## NOTICE OF ADDENDUM NO. 1

State of Rhode Island  
Solicitation Number 7553498  
CBLS Cooling Tower Improvements  
University of Rhode Island  
Kingston, Rhode Island

**DATE OF ADDENDUM:**                    **June 9, 2017**

# APPENDIX A

**SITE PLAN AND DETAILS**

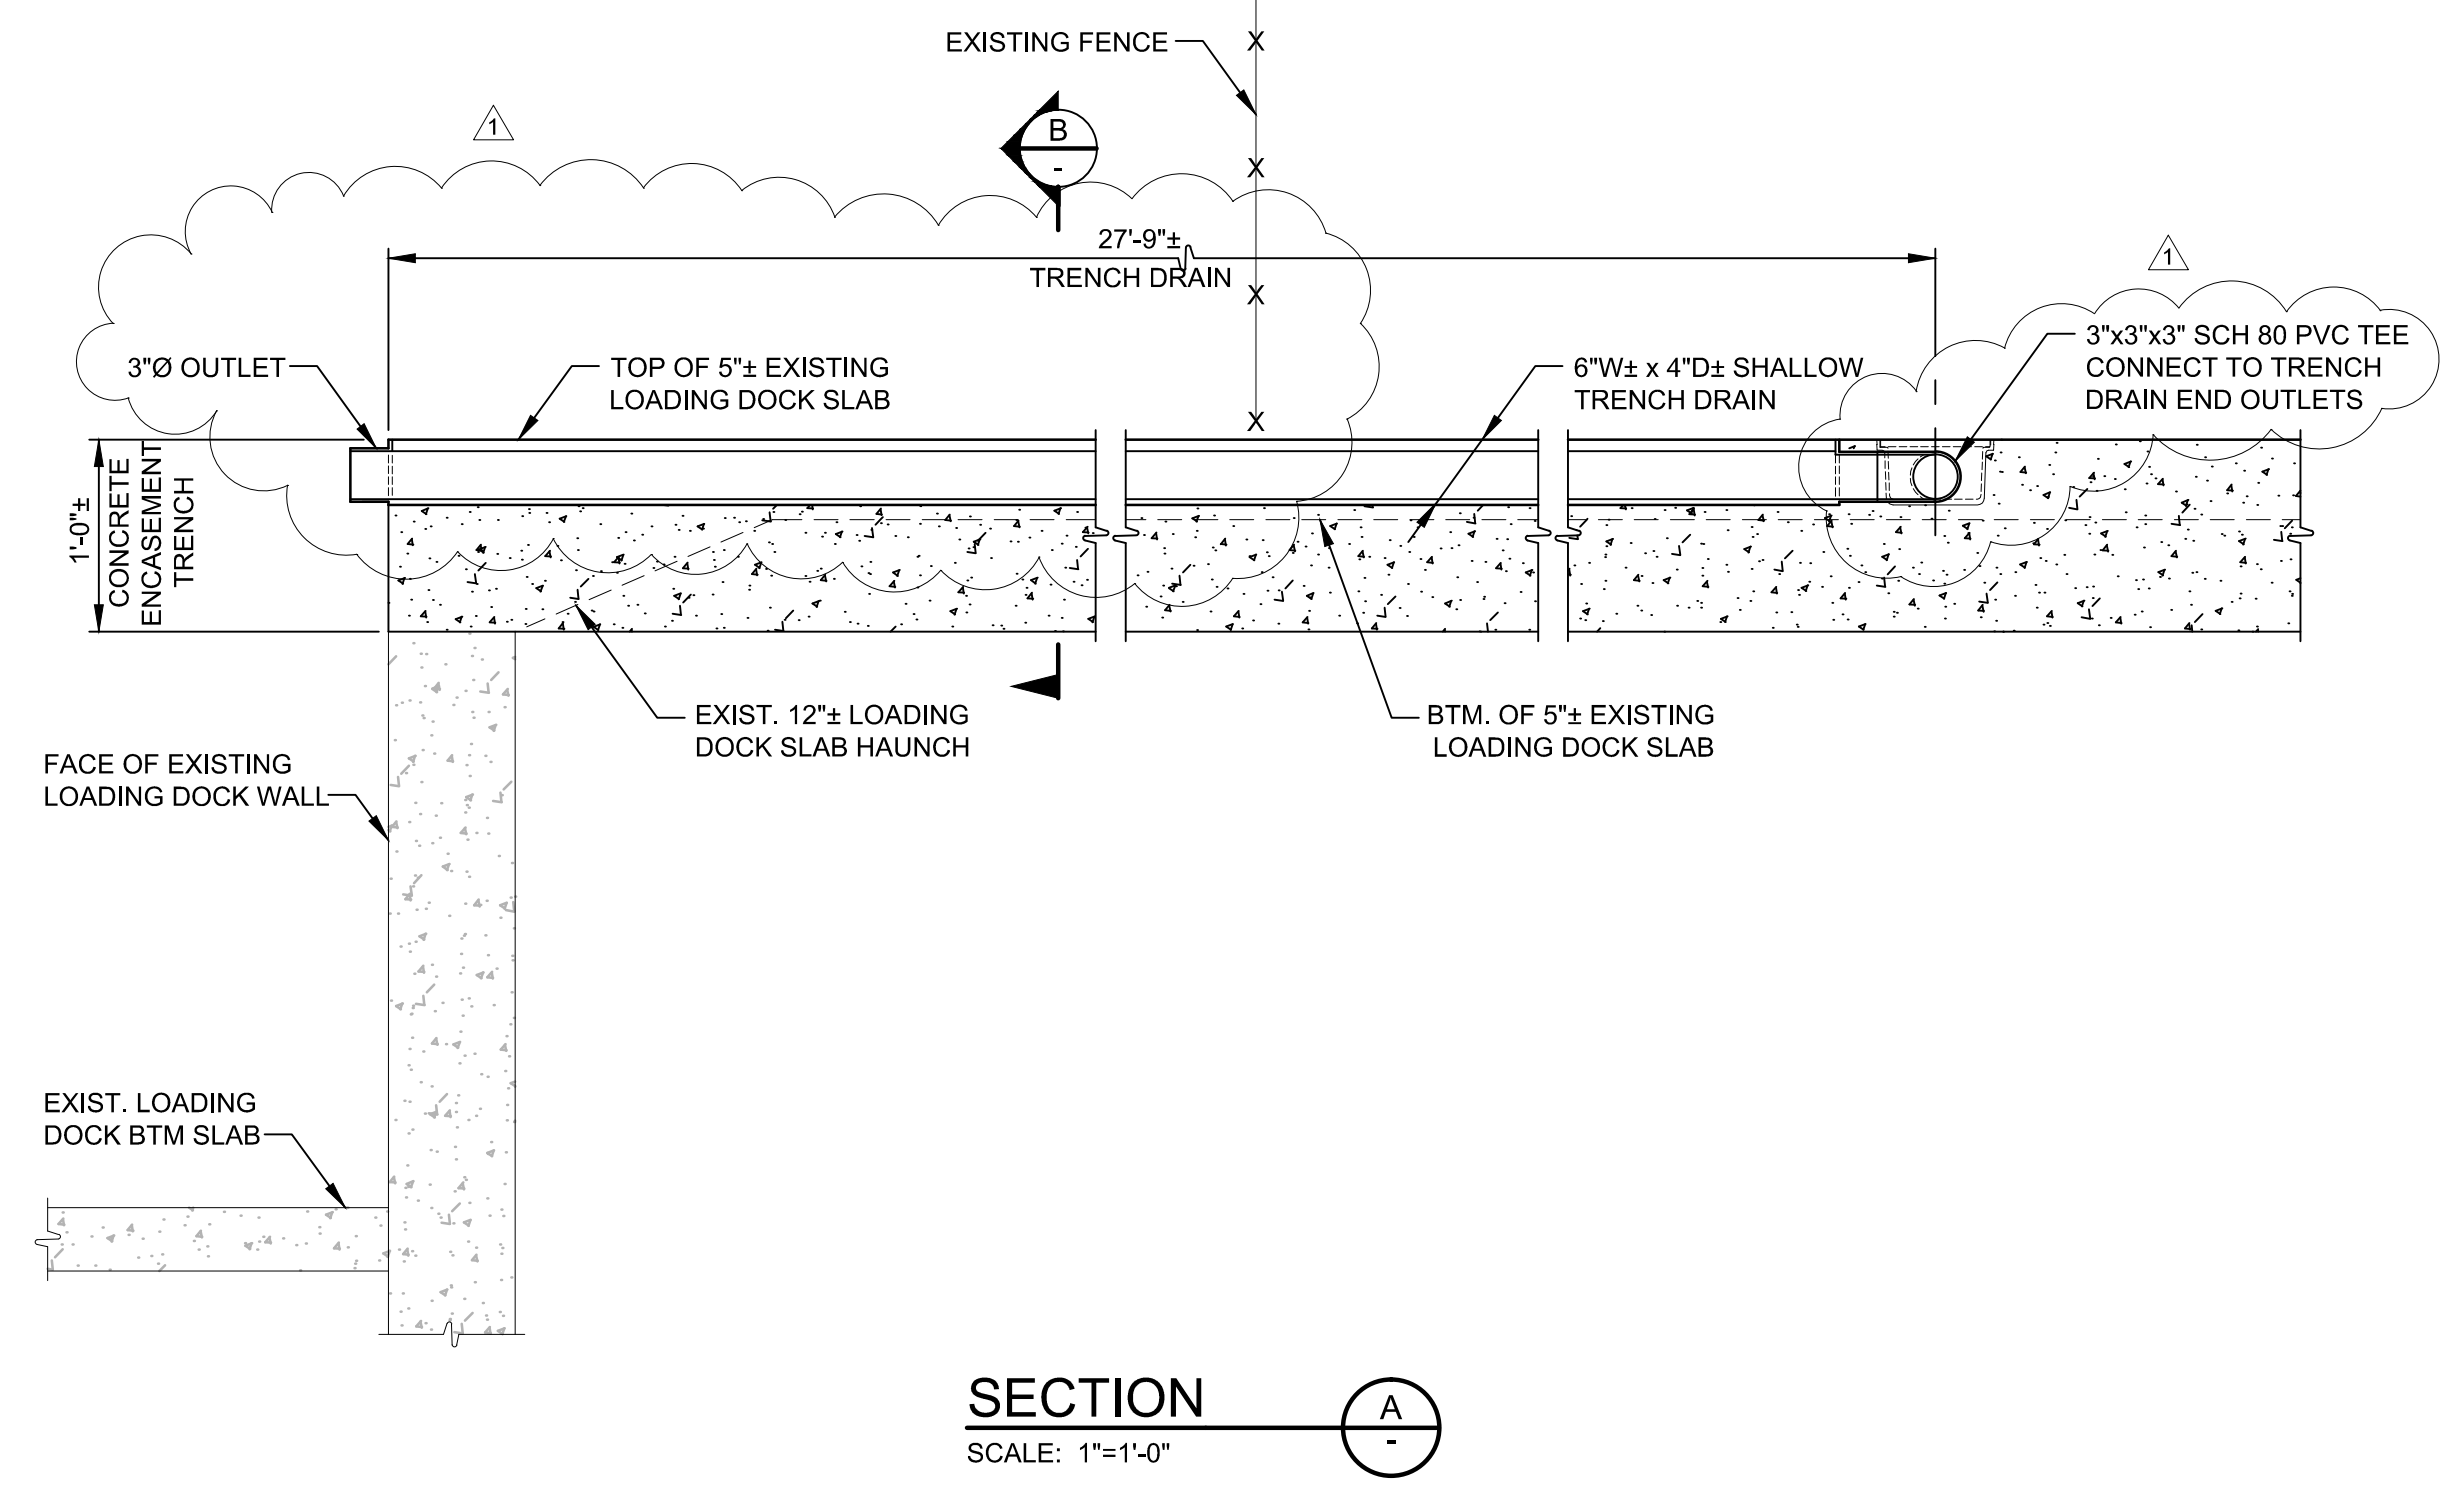
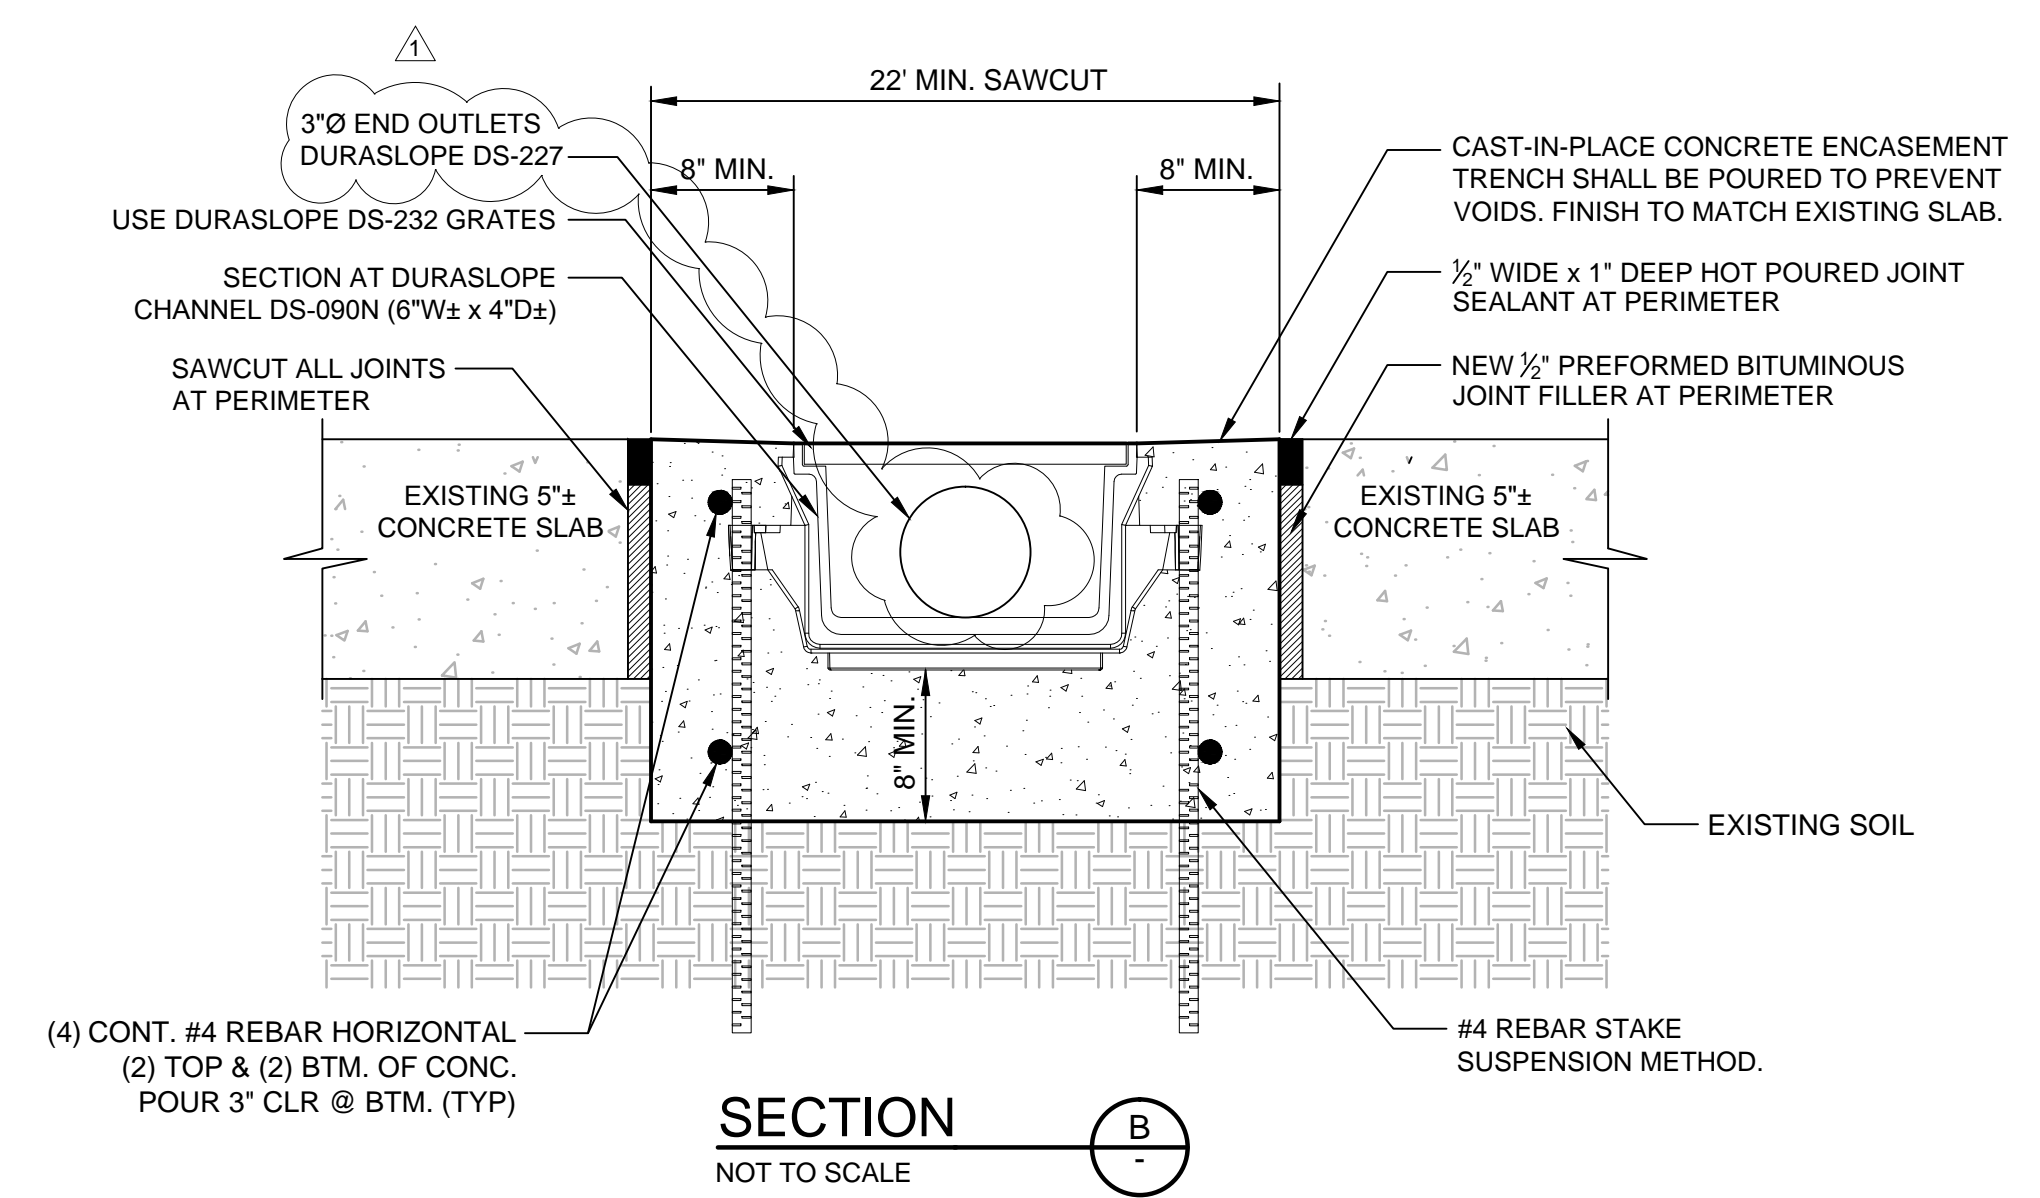
1. Delete Drawing No. 3, Sheet 3 of 3 and replace with attached Drawing No. 3 (Addendum No. 1).
2. Insert Appendix A - This section covers the installation of a new Fall Protection system at the Level Four Green Roof. The scope of work includes removal of existing roofing, creating openings through existing roof deck at roof anchor locations, installation of new Fall Protection System, enclosing roof deck and reinstalling new roofing at roof openings.
